Permit Number: 071311

has permission to New Master Bedroom & Storage Addition

AT 0 ONWAY AVE

City of Portland, Maine - Building or Use Permit Application

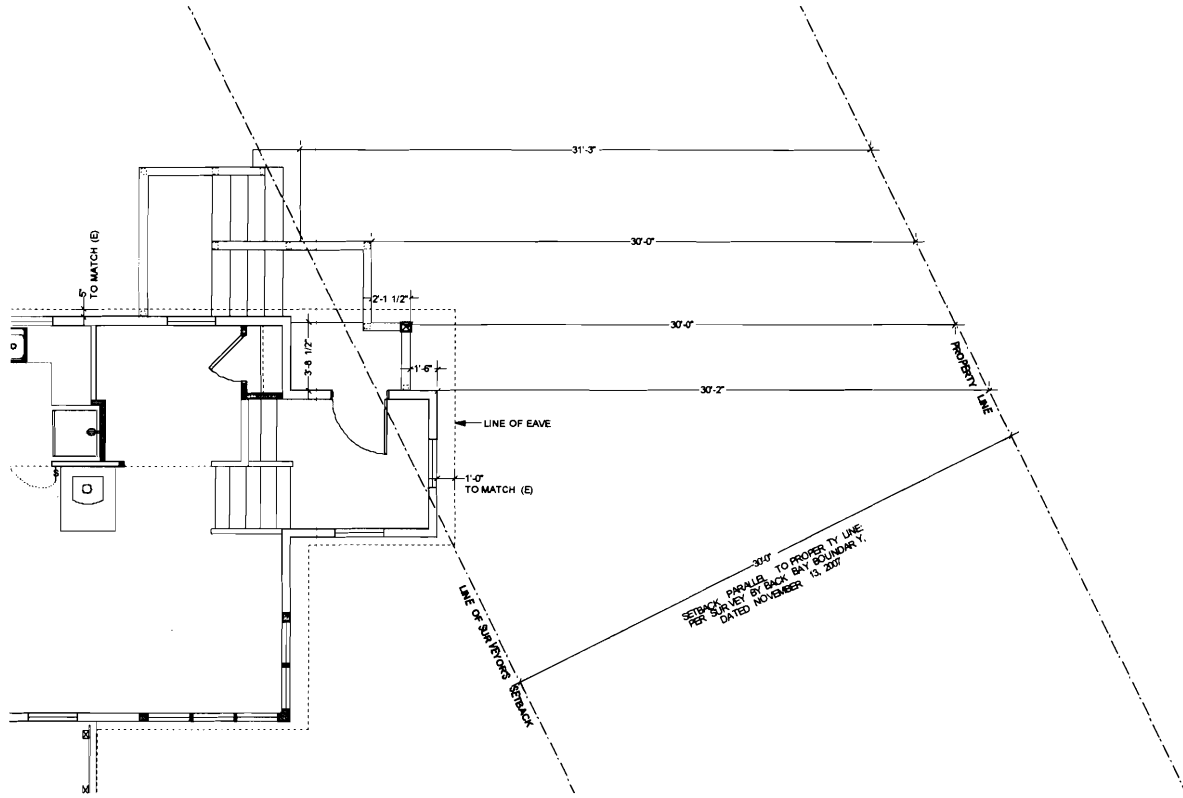
> Diane-
>
> From what I can see on the sketch, it looks like the setbacks would be
> met. Of course until I get a final plan submitted I can't make a final
> determination.
>
> Thanks, Ann
>
>>>> Diane Martin <dmartin@bdearch.com> 11/19/2007 4:40:14 PM >>>
> Hello Ann,
>
> Here is the sketch we discussed over the phone this morning. Thank you
> for
> taking a look at it. I just want to make sure we are totally on the
> same
> page in understanding what we can build on this site and where we can
> build
> it.
>
> If this meets your approval, we will finalize the revisions to the
> drawings
> and submit them to you for your official review as soon as possible.
>
> We look forward to hearing from you.
>
> Thank you for all your help.
>
> Diane.
>
> Diane Martin
> Architect
> BDE ARCHITECTURE
> 465 California Street, Suite 1200
> San Francisco, CA 94104
>
> Tel: 415.677.0966 Ext. 335
> Fax: 415.677.0964
>
> dmartin@bdearch.com
> www.bdearch.com

Thank you very much. This tells me we can go ahead with our submittal for approval.

NOV 8 2007

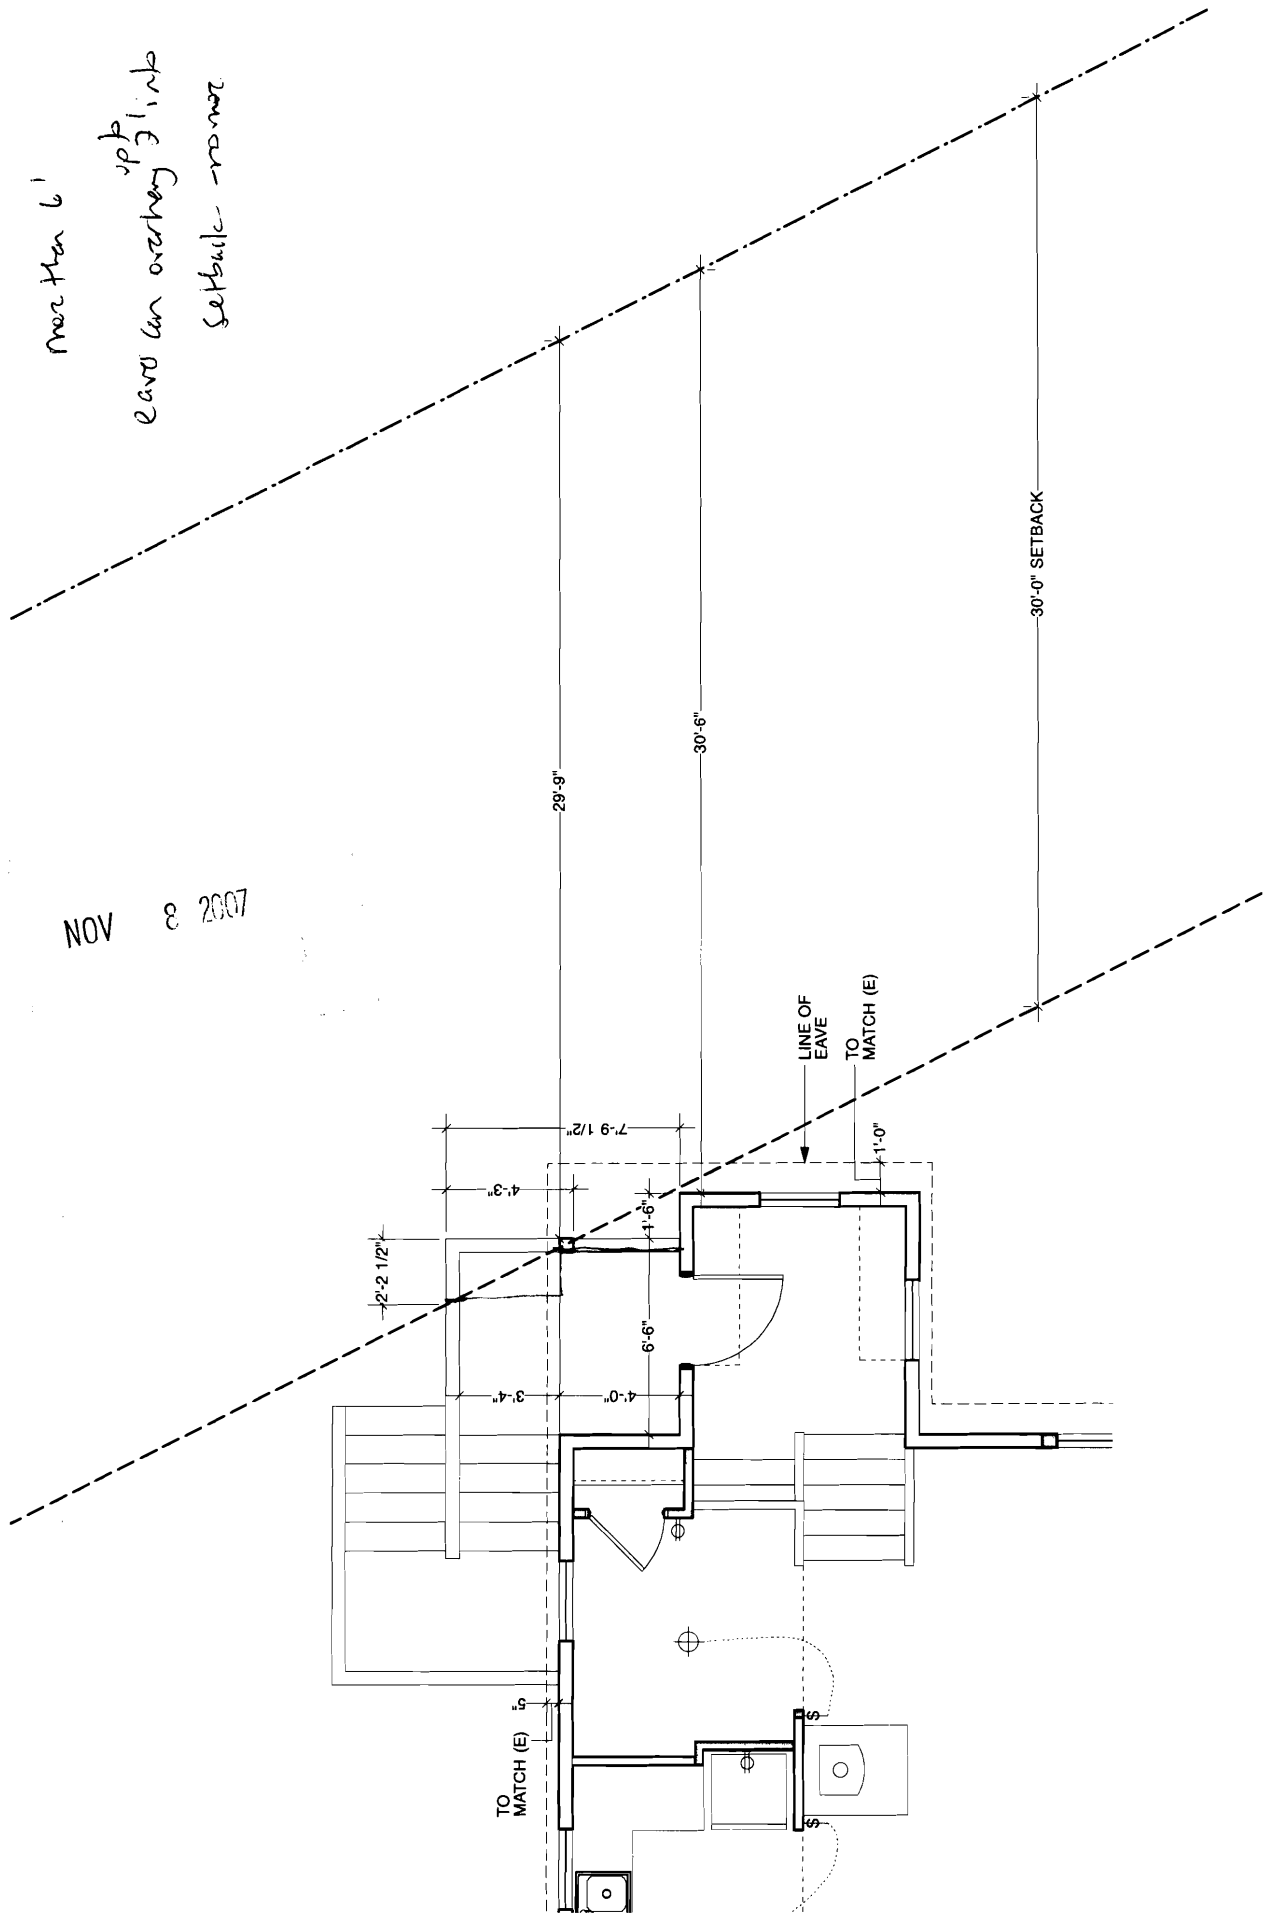
I have attached a sketch of the front porch and stair, as we discussed this morning over the phone.

As you can see the stair landing protrudes into the setback approx. 4.6 square feet, as does the roof eave if we continue the existing eave lines to meet over the porch.

As we discussed, we have pulled the porch in to align with the Northeast corner of the house, on the North wall. We have also pulled the East side of the porch in 1'6" inside the existing East wall entry pop-out, which still allows the front door to sit nicely in the existing entryway and the exterior trim to clear the porch railing.

We are hoping to be allowed this small infringement into the required front setback.

try E 11.3.

Section 14-425 not
work

more than 6'

spk
eaves can overhang 3' into
setback - no more
